Technical Service Information

EAGLE PREMIER ZF 4HP-18

NEUTRALIZES ON 3-4 UPSHIFT

Figure 1

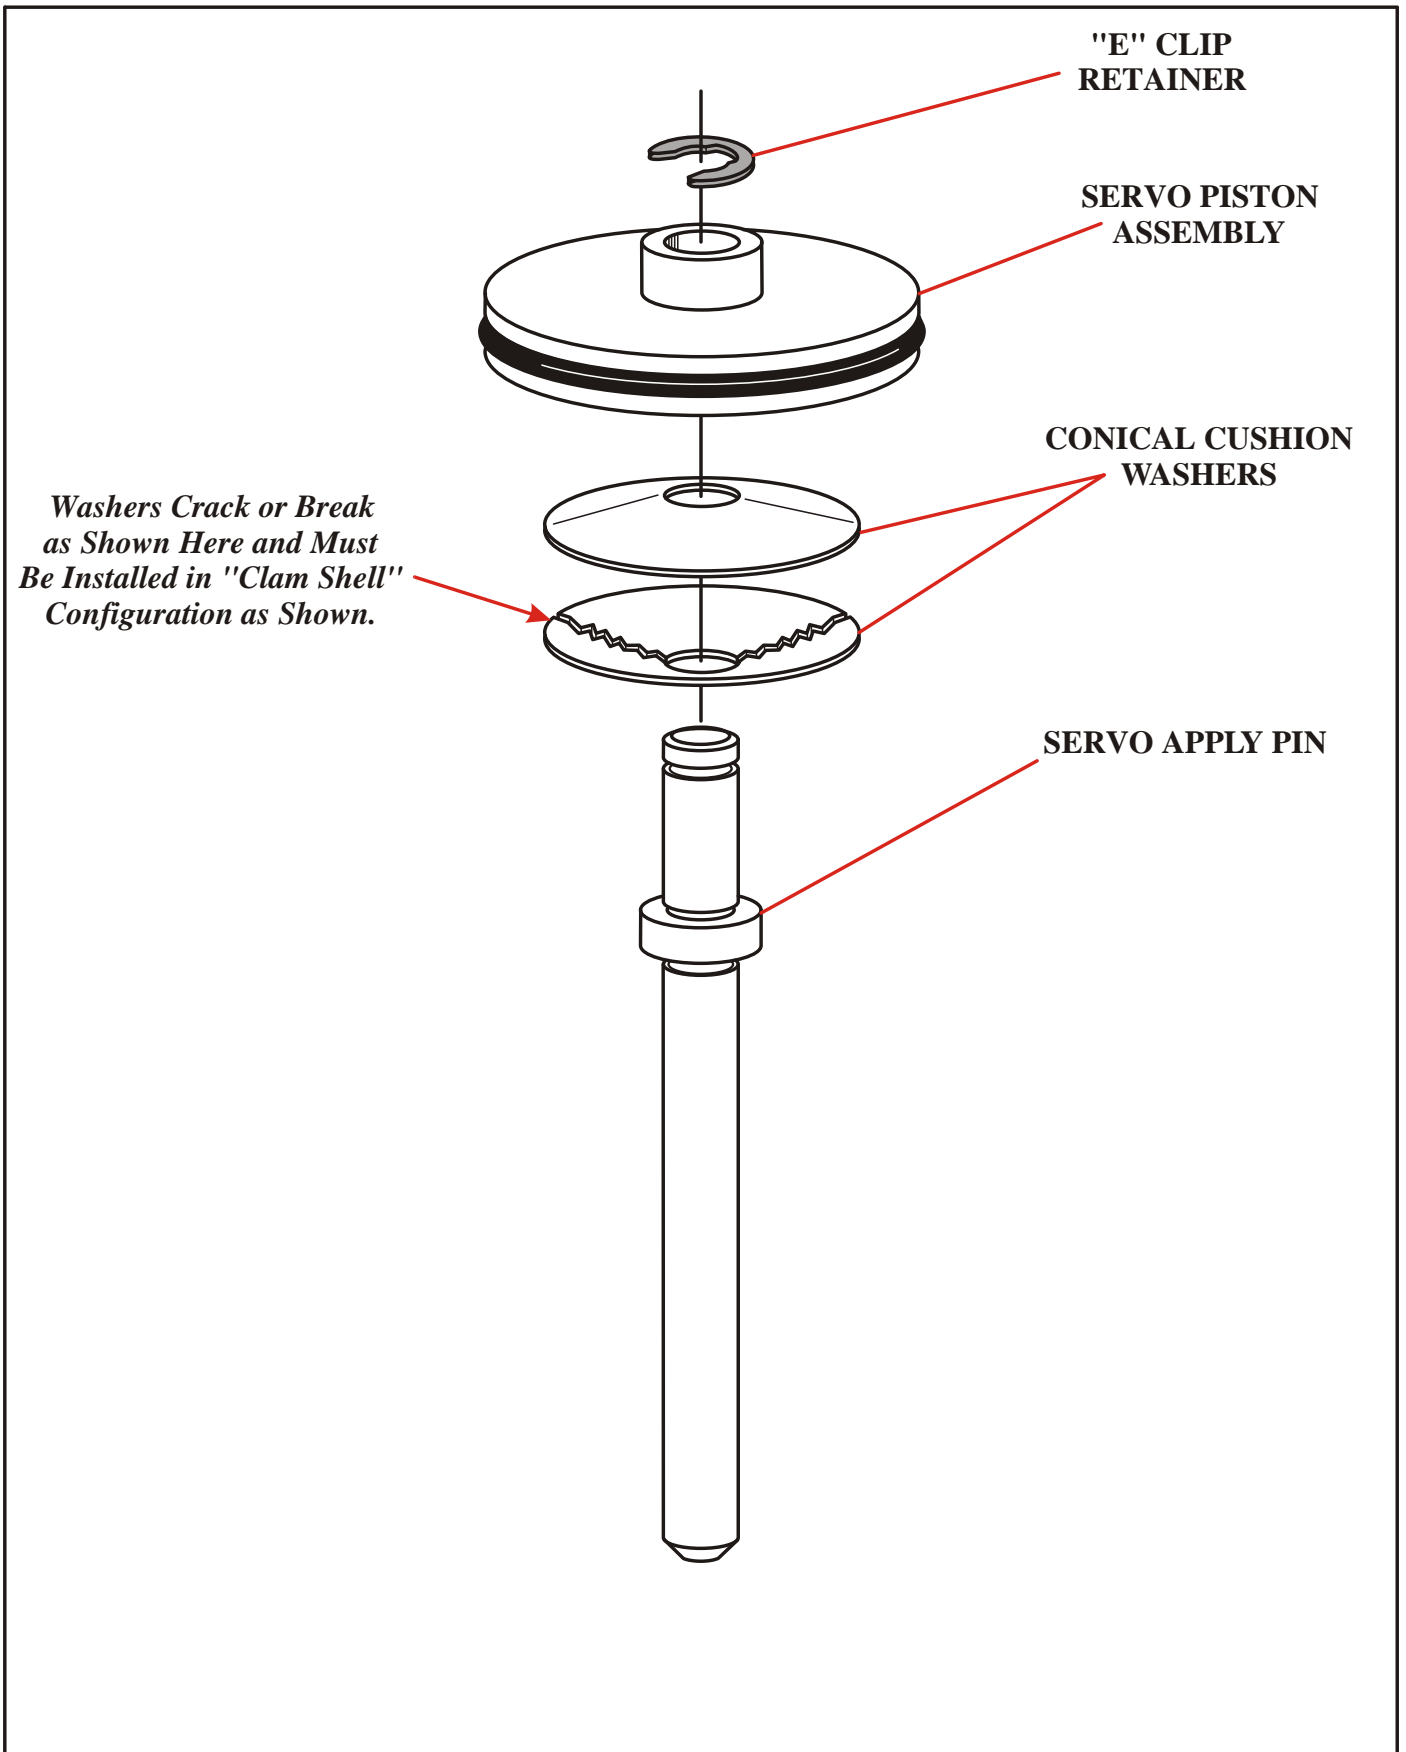
COMPLAINT: The transaxle neutralizes when a shift is made from third gear going into fourth.

CAUSE: It is not uncommon to find split conical cushion washers in the servo bore from the overdrive servo which interferes with the full travel of the servo piston preventing band apply (See Figure 1). The servo may be overlooked in the diagnostics as component application charts indicate the band is used for 2nd gear and second gear is operating correctly. A closer look at the application chart reveals that the band is used in second gear in addition to the intermediate clutch. If the band can not apply for second, the intermediate clutch will provide the hold on the sun gear achieving the 1-2 up shift.

CORRECTION: The conical washers are not serviced separately. If solid washers are used as a replacement, a tail end bump may occur on the 1-2 and more noticeably on a 3-4 up shift. The entire servo assembly can be purchased through an authorized ZF parts distributor. If good used conical washers are found, ensure that the washers are assembled in a "clam shell" configuration, as seen in figure 1.
